# Access Compliance Report

## Public Rights-of-Way

Intersection ID: 29998	Main Street: WINDING_RIVER_DR	Cross Street: YEARWOOD_LN	Location: SE
ADA ID: A8297AB2FD97	Ramp Type: PerpDiag	Initial Pass/Fail: Pass	Overall Compliance: No
		Severity Score: 10

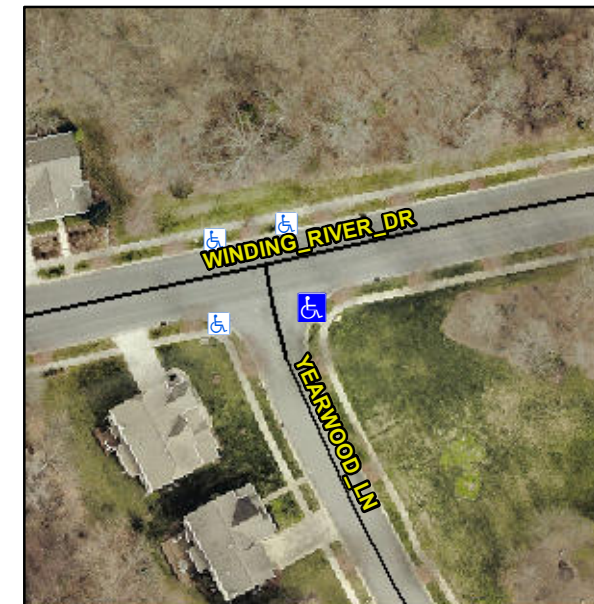
**Not Found, R304.2.1, R304.2.2-Perp, R304.3.2-Para, R304.5.3, R305.1.4, R305.2, R302.7.2**

**Remove & Replace Curb Ramp With Two New Directional Ramps or Equivalent.**
